# PONY 2/4

## Field Update v.06142019

### Remove Pod Chute Reinforcement Bar

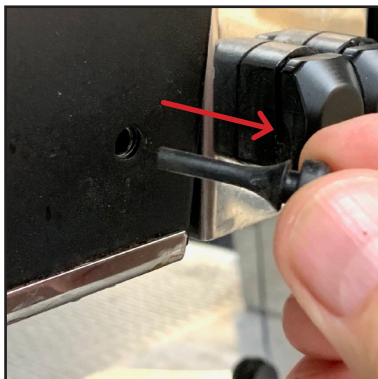
To correct problem associated with Chute Reinforcement Bar sometimes interfering with the pods dropping into the drawer.

Remove the Reinforcing Bar from both Chutes.

Can be done in place, no need to remove the Chutes first.

Pull the rubber posts out

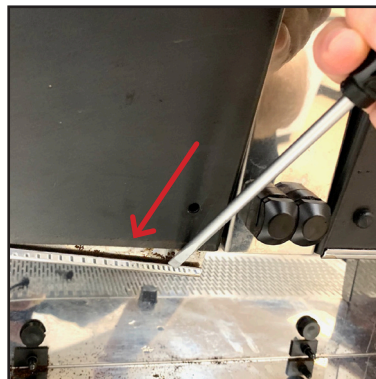
Push the bar off with a screwdriver

Remove bar and discard

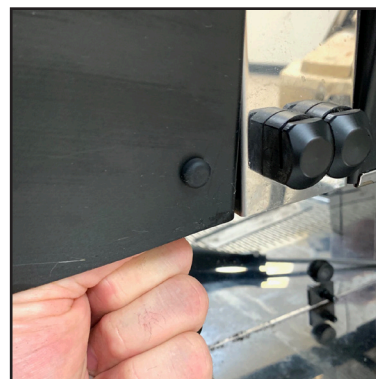
Press the posts back in place

Pull from the rear to seat

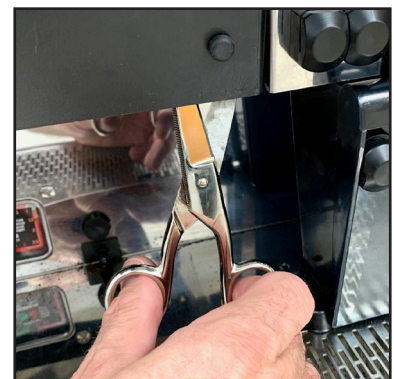
Trim the rubber tab off
